SB-10037065-6239SI M11 02 07
EngineMay 2012
Technical Service

This Service Information bulletin supersedes SI M11 02 07 **dated April 2012.**

SUBJECT**Rattle Noise from Engine****MODEL**

R55 Cooper S with N14 engine

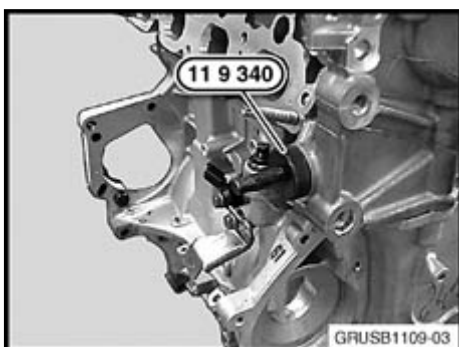
6. Remove the right-hand wheel arch trim to access the crankshaft central bolt.
7. **NEW** Disconnect the battery and remove the ignition coils and the spark plugs. Turn the engine in the clockwise direction by hand to move the flywheel to approximately 90° before TDC. Rotating the engine counterclockwise may cause an incorrect measurement.

8. Install the locating pin (Special Tool 11 9 590) to lock the position of the engine.

Do not remove the cylinder head cover! Do not install camshaft locking tool during this procedure. To achieve an accurate measurement, the camshafts need to rotate.

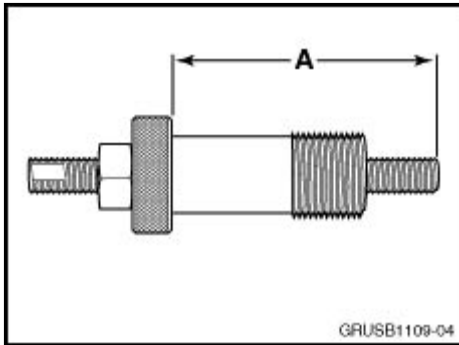
10. Fit the chain tensioner (Special Tool 11 9 340) without the seal ring and with the lock nut loose. Pretension the chain tensioner with Special Tool 00 9 250 to **0.6 Nm**. Finger-tighten the lock nut on Special Tool 11 9 340.

Gently turn Special Tool 00 9 250 while applying the torque. Quickly rotating the tool will provide an inaccurate measurement result.

11. **NEW** Remove the chain tensioner Special Tool 11 9 340 from the engine, with the lock nut still tight. Measure the distance (A), as described in the illustration.

12. **NEW** If distance (A) is less than 68mm (and the noise can be reproduced only between 1,600-1,800 rpm), only replace the chain tensioner with P/N 11 31 7 607 551 and substitute the seal ring supplied with the new chain tensioner with improved seal ring P/N 11 31 7 631 972 (refer to parts list A).

13. **NEW** If distance (A) is 68mm or greater (and the noise is reproducible both at 1,600-1,800 rpm range as well as at idle speed when cold), replace the following components in the list below (refer to parts list B).
- Guide rail
 - Tensioner rail
 - Sliding rail
 - Sprocket on the crankshaft
 - Bearing bolts for the tensioner and guide rails
